RTCA Special Committee 209
ATCRBS / Mode S Transponder
Meeting #3

Review of P1-P3-P4
Accept / Reject Requirements
In Response to Action Item 2-7

Presented by R.H. “Bob” Saffell

Figure 2: Simplified P4 Acceptance

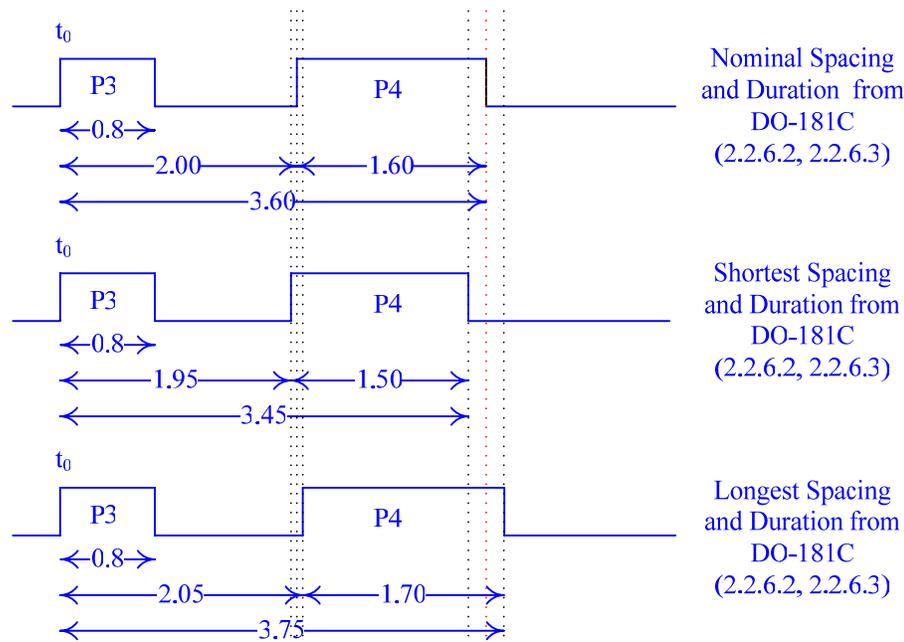
As illustrated in the following Figure 2, you could also take nominal P3-P4 spacing of 2.0 microseconds and nominal P4 duration of 1.6 microseconds, to get 3.6 microseconds. Then subtract 1.0 microseconds for the shortest P4 (1.5), subtract 0.05 microseconds for the shortest P4 spacing (1.95), and you get $3.6 - 1.0 - 0.5 = 3.45$ microseconds.

Likewise, take the same nominal 3.6 microseconds, add 1.0 microseconds for the longest P4 (1.7), add 0.05 for the longest P4 spacing (2.05), and you get $3.6 + 1.0 + 0.05 = 3.75$ microseconds.

SARPs 3.1.2.4.1.2.2.1 places must accept requirement on P4 leading edge at 3.45 to 3.75 microseconds from the leading edge of P3. As such, the SARPs are placing the trailing edge at the same place that the DO-181C MOPs are as indicated in the above figures.

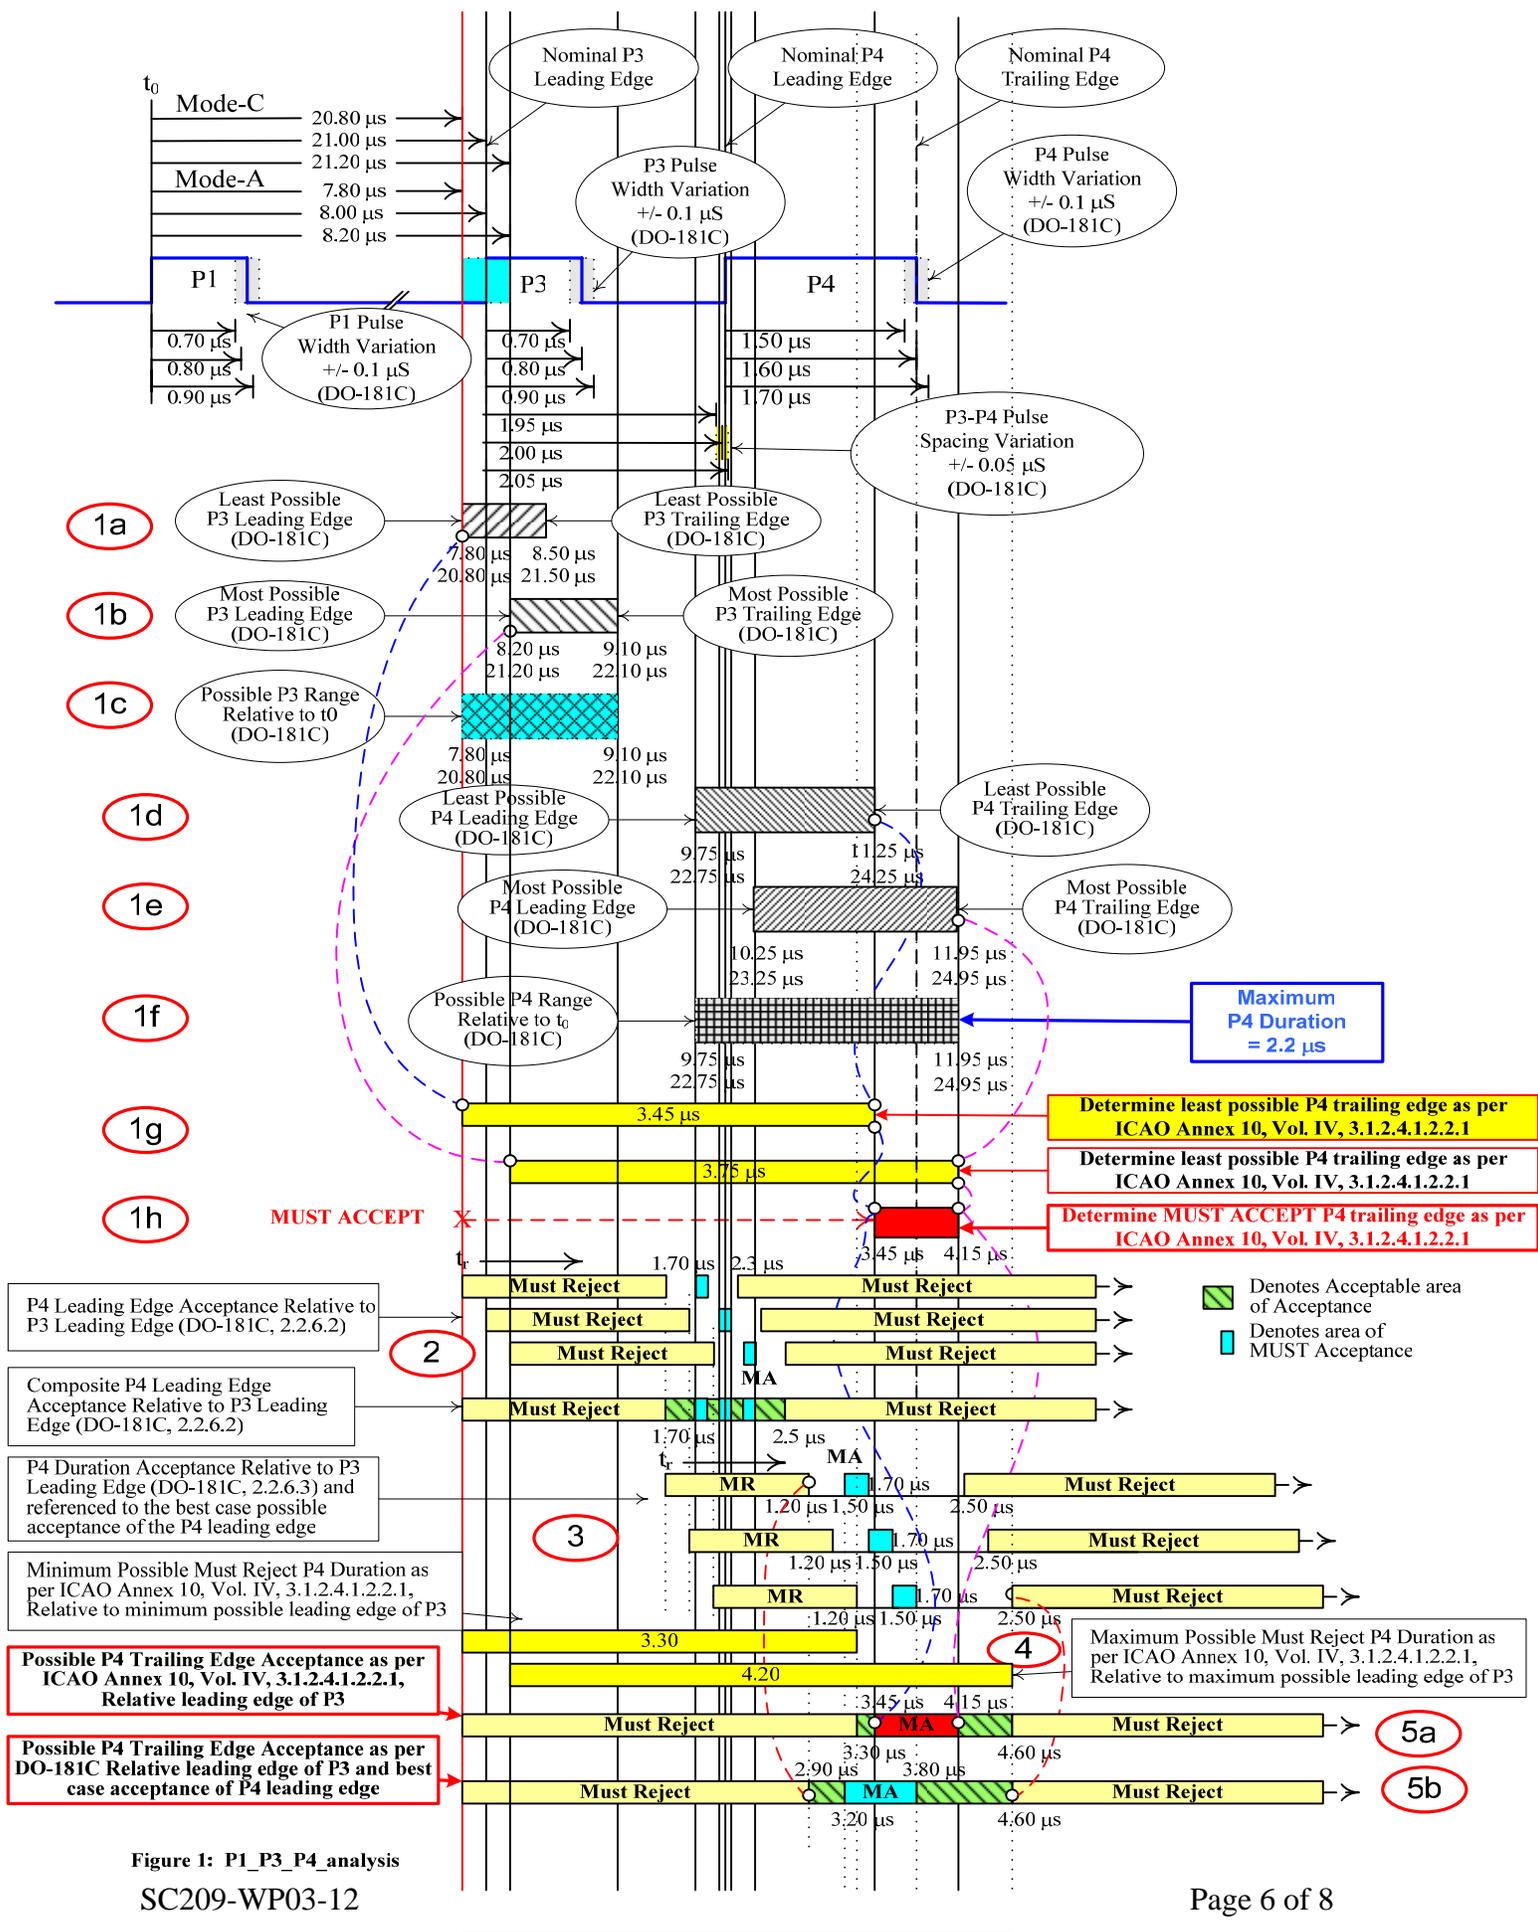
Referring to Figure 1, below, lines indicated by bubble **3** were inserted to show the duration of P4 in accordance with RTCA DO-181C. Lines indicated by bubble **4** were inserted to show the trailing edge of P4 in accordance with ICAO Annex 10.

Virtually all possible combinations were tried in order to get the Must Reject Criteria to line up with those of ICAO Annex 10, but to no avail. In fact, the line indicated by bubble **5b** would indicate that the trailing edge of P4 could occur anywhere between 2.90 and 4.60 microseconds after the leading edge of P3. Needless to say, this does not agree with ICAO Annex 10 which requires that the trailing edge occur between 3.30 and 4.20 microseconds after the leading edge of P3, as indicated by the Figure 1 lines indicated by bubble **4**.

- (1). Consider NOMINAL P3—P4 leading edge spacing of 2.0 microseconds

Add 1.2 microseconds for Minimum Duration of P4 in accordance with RTCA DO-181C and the result is 3.2 microseconds.

Add Minimum Rise and Fall Times of P4 of 0.05 microseconds and the result is 3.3 microseconds to the trailing edge of P4 as per ICAO Annex 10.

- (2). Consider NOMINAL P3-P4 leading edge spacing of 2.0 microseconds, once more Add 2.5 microseconds for Maximum Duration of P4 in accordance with RTCA DO-181C and the result is 4.5 microseconds.

Subtract Maximum Rise Time of 0.1 microseconds and Maximum Fall Time of 0.2 microseconds, and the result is 4.2 microseconds to the trailing edge of P4 as per ICAO Annex 10.

Therefore, the establishment of the P4 trailing edge rejection criteria by ICAO Annex 10 can at least be explained.
